From: [Claire Cornelius](#)
Sent: Wednesday, August 28, 2013 6:49 PM
To: shaw-residents@virginmedia.com
Subject: Revised response to the SRA gridlock response.

Thank you for your email and report entitled Ridgeway Farm – A Recipe for Gridlock of the 4th May 2013, my original response of 6th June 2013 and our subsequent meeting with Gwillam Lloyd, Head of Highways & Transport on 4th July 2013 to discuss and compare our respective views.

Figure 2.4 - Urban Extensions; Suburban Sprawl vs Connected Development

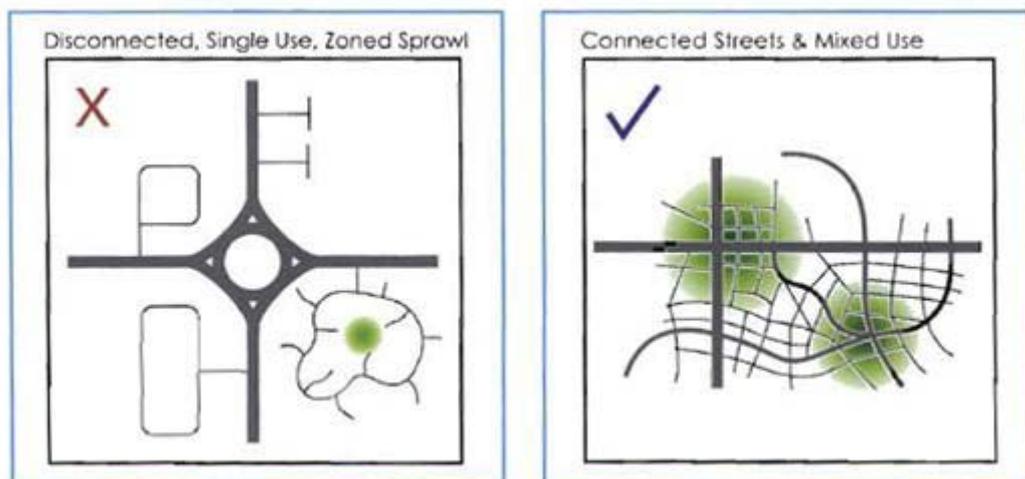
Manual for Streets highlights design standards for different road users and encourages moving away from hierarchies of standard road types, developing street characters that strike the balance between place and movement on busy streets. It is no longer considered appropriate to design streets that take traffic around the edge of development. Taking traffic through the centre makes it an accessible, inclusive and active place that connects into the urban fabric. I use a diagram from Manual for Streets 2 to illustrate.

Figure 7.1 Illustrates what various carriageway widths can accommodate. They are not necessarily recommendations.

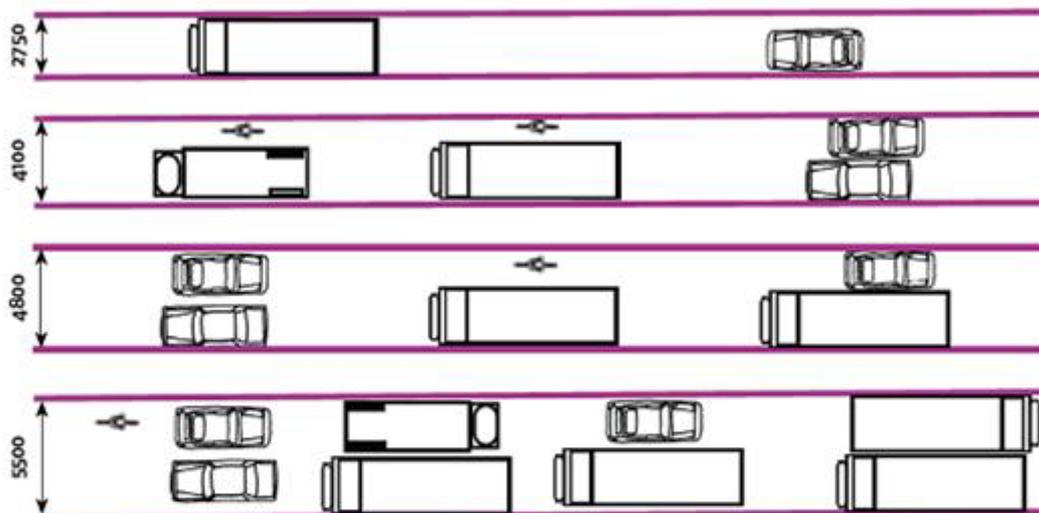
The spine road width of 6.5m is appropriate subject to localised widening to accommodate larger vehicle swept paths. At 6.5m width you could still allow two cars to pass if a vehicle were to be parked on the spine road. An average parallel parking space is 2m wide, leaving a width of 4.5m. Two cars can pass in a straight line with a width of 4.1m. There are locations where this currently occurs however there are locations where drivers choose not to undertake this manoeuvre. I would suggest from my experience that where there are high volumes of traffic this will commonly occur as choosing to wait will result in delays however where flows are lighter a driver may choose to wait.

You will note from the Manual for Streets 1 diagram above that two HGV's can pass on a road width of 5.5m.
